# EVALUATION OF DRAFT HANDBOOK FOR SEALS IN NAVAL AIRCRAFT

Evaluation of Draft Handbook for Seals in Naval Aircraft

J. M. McGrew

SHAKER RESEARCH CORPORATION Northway 10 Executive Park Ballston Lake, N.Y. 12019

Figure C-1

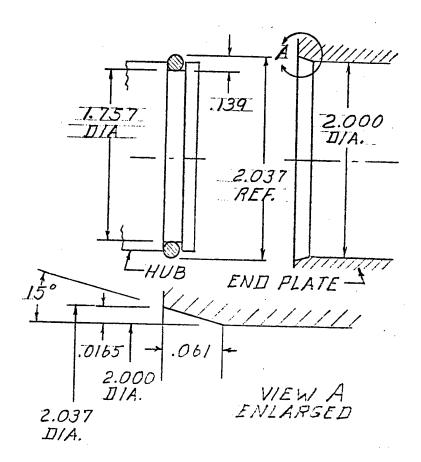
- in Figure C-1. If there is not room for a chamfer this long, a .016 inch radius would be preferable to the tiny chamfer presently called for.
- 6) Page 44, paragraph 6.1.1.2: O-rings are not normally recommended for sealing rotary shaft except where the speed is low. However, a low limit of 8 in/sec (40'/min) seems excessively low. Is this perhaps due to some peculiarity of the "Rev-O-" seal design? If so, it should be stated, otherwise there will be confusion between this statement and Table 5-5 page 5-36 of Appendix B suggesting O-rings for speeds up to 1500' per minute if the glands are properly designed.
